Packet Guide
City of Charlottesville
Board of Architectural Review
Regular Meeting
September 17, 2024, 5:30 p.m.
Hybrid Meeting (In-person at CitySpace and virtual via Zoom)

**City of Charlottesville
Board of Architectural Review
Staff Report
October 15, 2024**

Project: Modifications to previous CoA - New apartment building.

1301 WERTLAND ST.
PARCEL 040303000
PROPOSED AMENDMENTS TO COA
PRESENTED BY

PROPOSED EAST ELEVATION

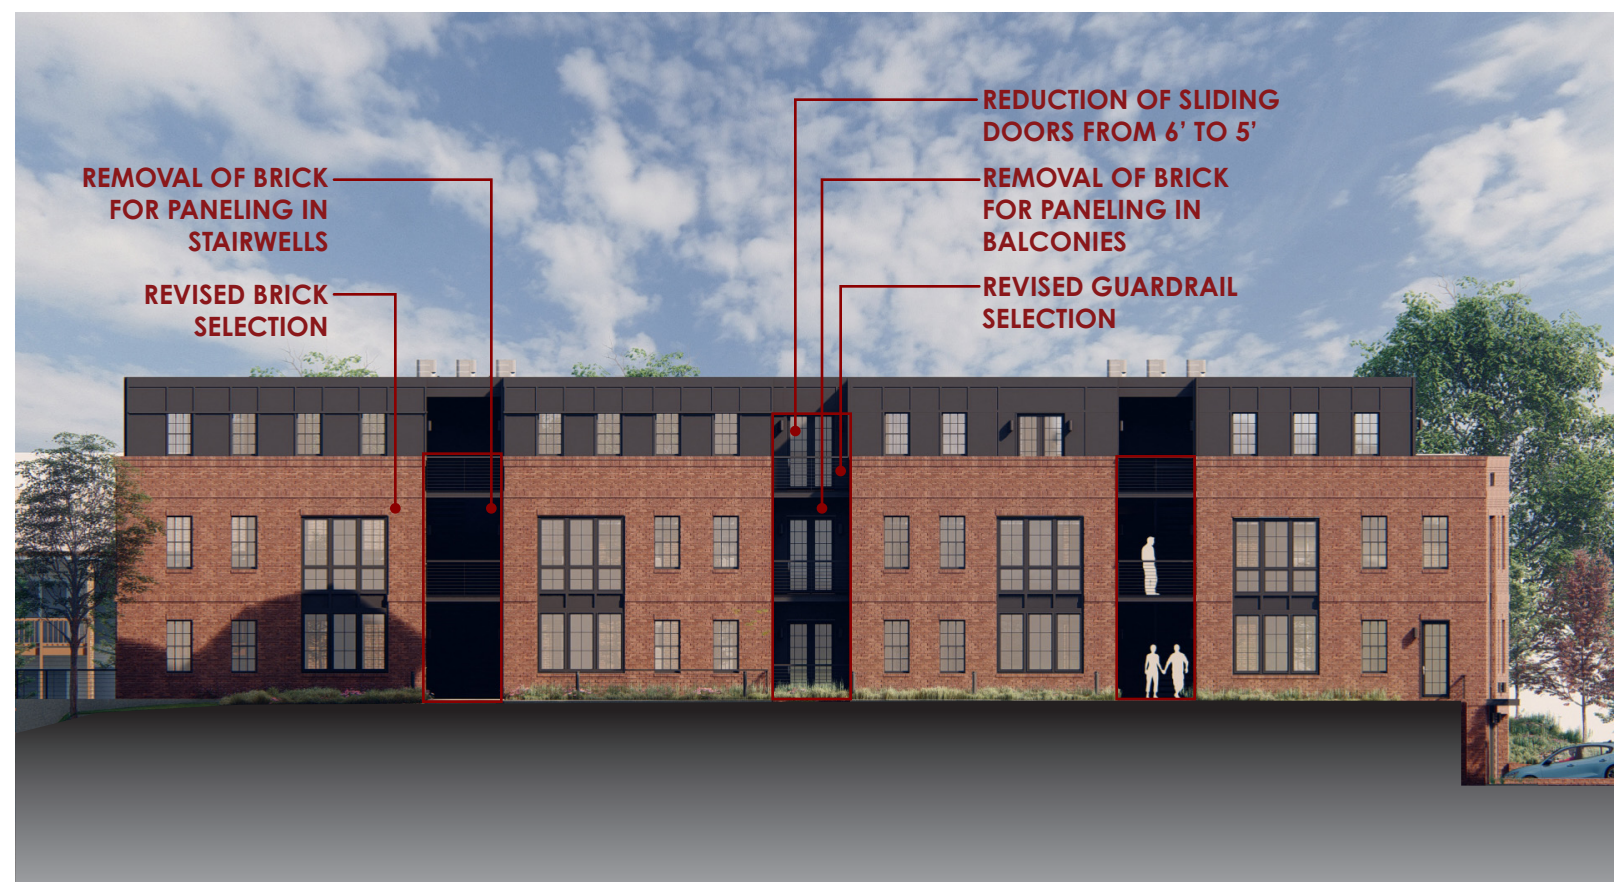
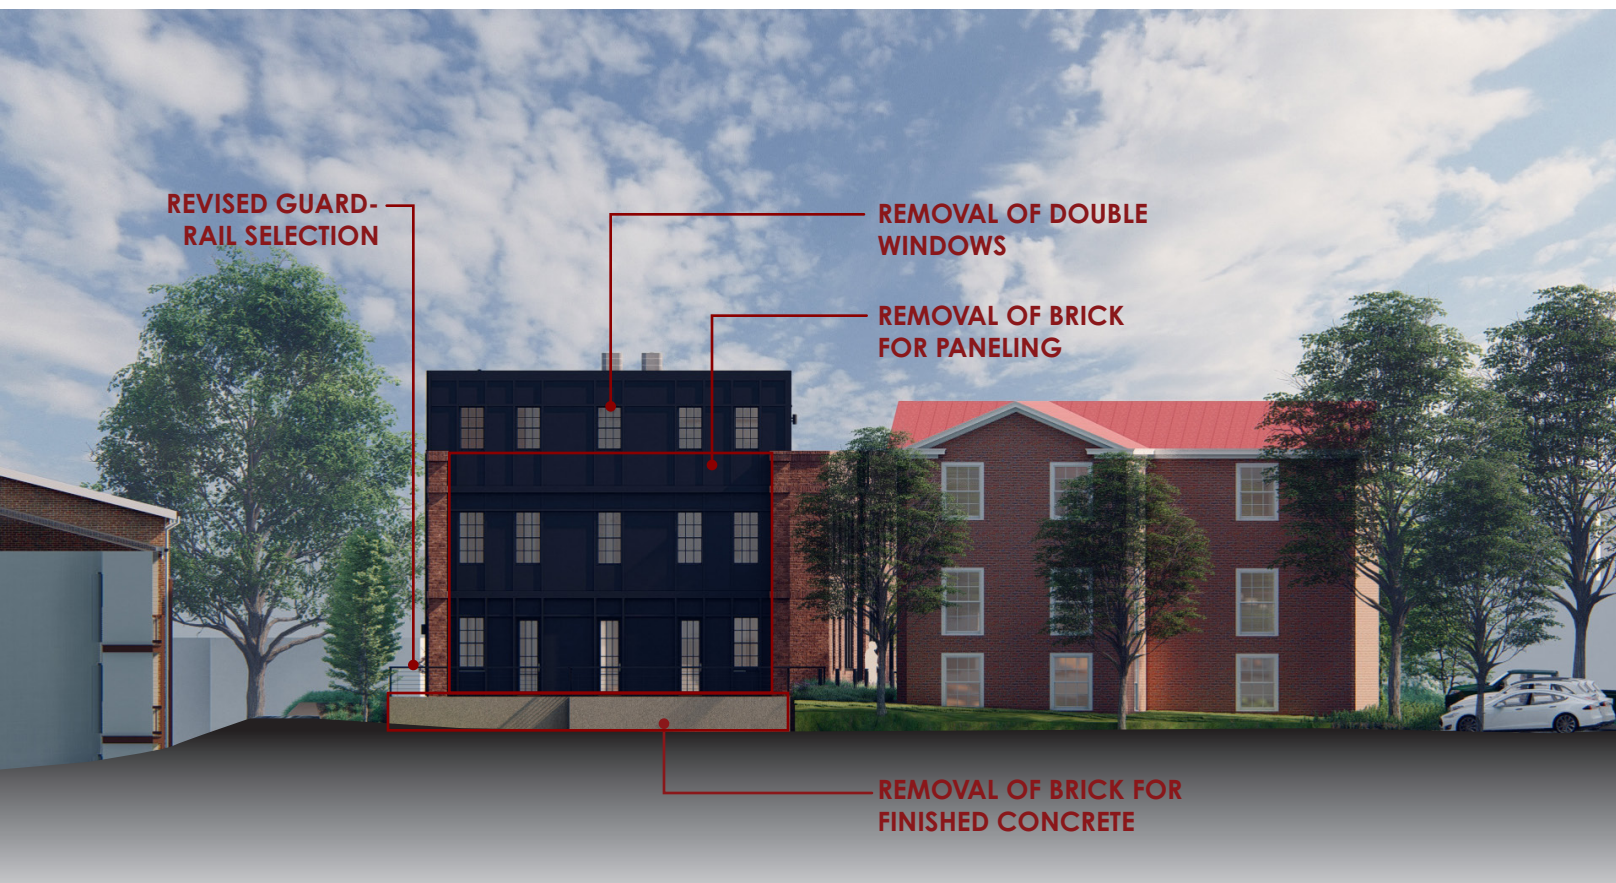
- Alternate brick and mortar selections.
- Alternate balcony railings: Trex Signature Aluminum Railing. Color: “Charcoal Black”.
- East and west (side) elevations:
 - Replace brick at 1st and 2nd floor balcony and stairwell walls with painted, cement-board panels.
 - Reduce width of sliding doors from 6-feet to 5-feet.
- North (rear) elevation:
 - Replace twin windows and doors with single units.
 - Building wall: Replace brick with painted, cement-board panels.
 - Alternate railing: Trex Signature Aluminum Railing. Color: “Charcoal Black”.
 - Retaining wall: Replace brick with finished concrete.

PREFERRED ALTERNATIVE: PINEHALL BRICK
OLD YORK TOWN O/S TUMBLED
(WEST FACADE)

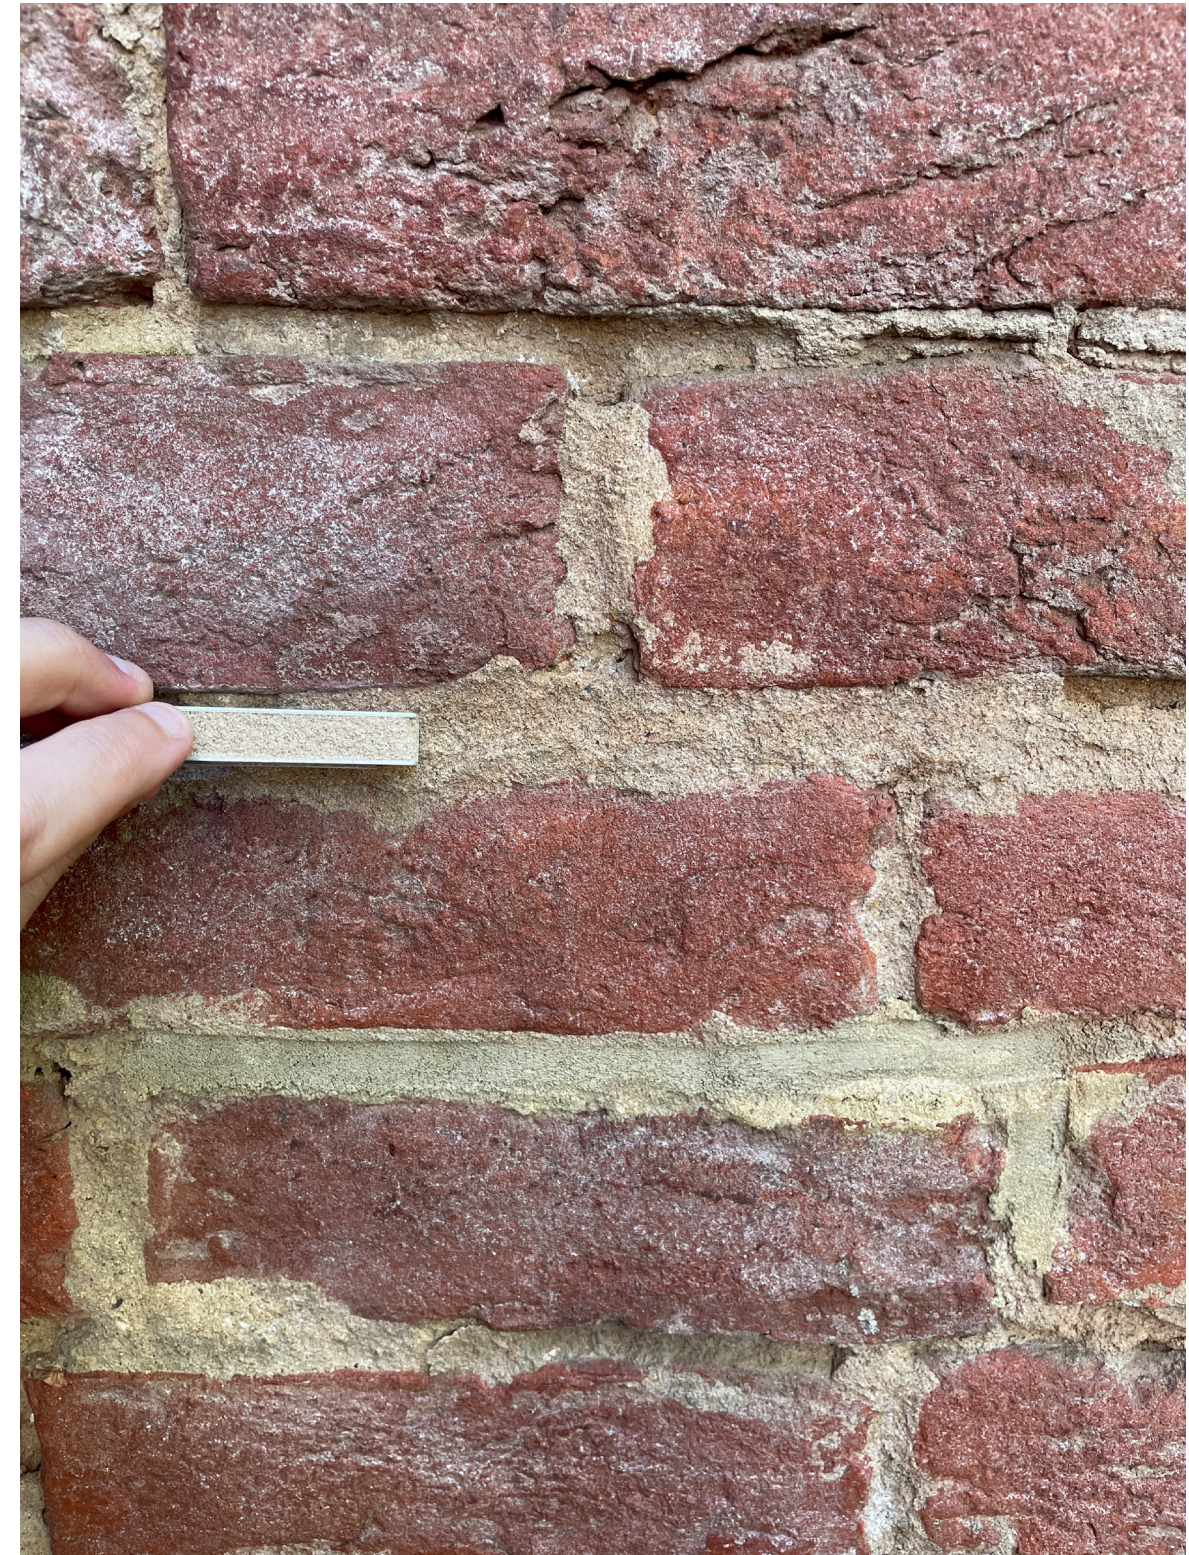
Staff has no issues with proposed modifications to the railings, windows, doors, and rear retaining wall and the proposed use of cement panels in lieu of brick at sections of the east, west, and north elevations. Individually, these would likely be OK’d by staff as routine changes typical when a project moves toward construction. However, viewed cumulatively with the requested change to the brick and mortar, staff determined formal review by the BAR was necessary.
